Subject: Crystal River Unit 3 – License Amendment Request #290, Revision 1
Probabilistic Methodology to Determine the Contribution to Main Steam Line Break Leakage Rates for the Once-Through Steam Generator from the Tube End Crack Alternate Repair Criteria

**Addendum B Dated August 10, 2005 to Topical Report 2346P, Revision 0
Probabilistic Leakage Assessment of Crystal River Unit 3
Steam Generator (SG) Tube End Cracks**

**Response to NRC Request for Additional Information (RAI)
Regarding License Amendment Request #290, Revision 0**

Figure 4-1, OTSG Tube End Leakage vs Delta Dilaton

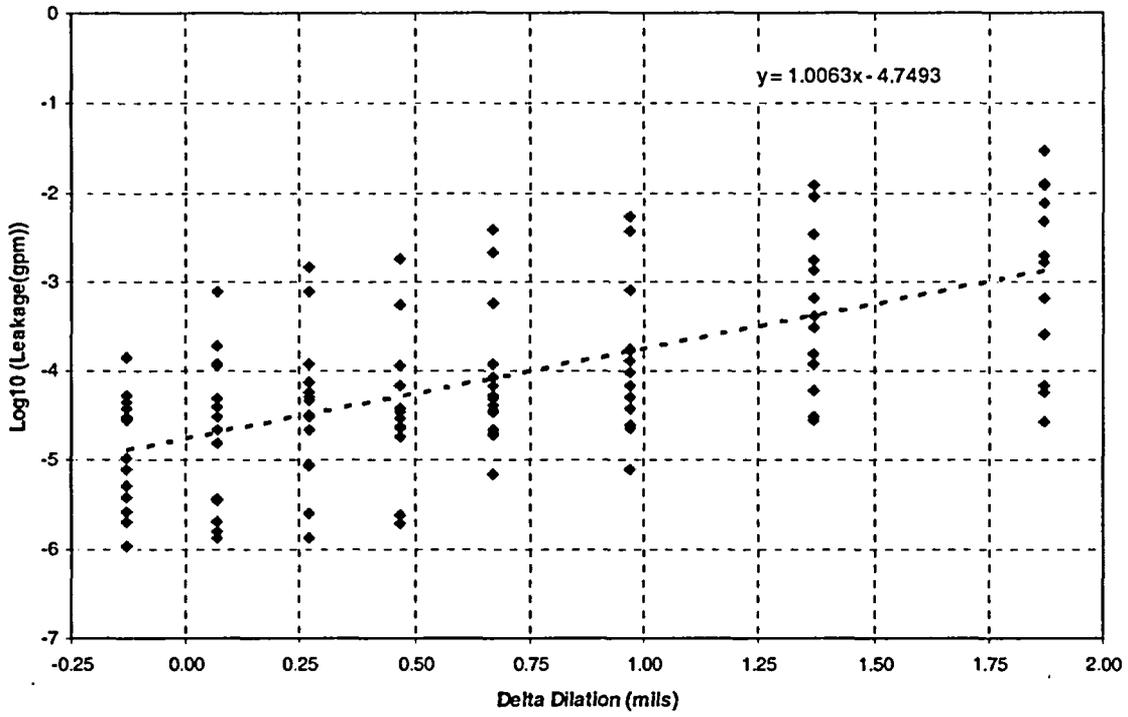
- 3. Tables 6-1 and 6-2 in Attachment A of the licensee's January 27, 2005 submittal purport to benchmark the probabilistic approach (LeakTEC) with the deterministic approach for performing condition monitoring and operational assessment. These Tables suggest the probabilistic approach reduces the leakage estimates by roughly 2/3 compared to the reference deterministic approach. However, whereas the leakage versus delta dilation (or tubesheet radius) data used in the probabilistic analysis had been adjusted to reflect the change in tube diameter associated with the Crystal River 663 lb (max.) axial load, the deterministic approach utilized leakage data reflecting a change in tube diameter associated with a 3060 lb (max.) axial load. In addition, the deterministic method considered conservative step functions for the leak rate versus delta dilation and tubesheet radius relationships rather than more realistic smooth relationships. What is the effect on the deterministic results in Tables 6-1 and 6-2 if the leakage data upon which they are based are revised to reflect the tube diameter change associated with the Crystal River 663 lb (max.) axial load and if the leakage versus delta dilation and tubesheet radius relationships utilized were based on continuous curves (developed by interpolation) rather than conservative step functions?**

Additional deterministic leakage estimates have been developed to reflect the effects discussed in RAI #3 and Addendum B (Attachment E) has been revised to include the information in Tables 6-1 and 6-2. The results of this work reveal that the elimination of tubesheet zones in favor of a continuous approach reduced the End of Cycle 13 (EOC13) estimate of total leakage returned to service by 12% to 15% as compared with deterministic estimates documented in the Condition Monitoring/Operational Assessment (CMOA). Accounting for the affect of axial load on delta dilation in the leak test data further reduced this estimate by an additional 45%. Removal of both of these sources of conservatism from the deterministic leakage calculation methodology yields results
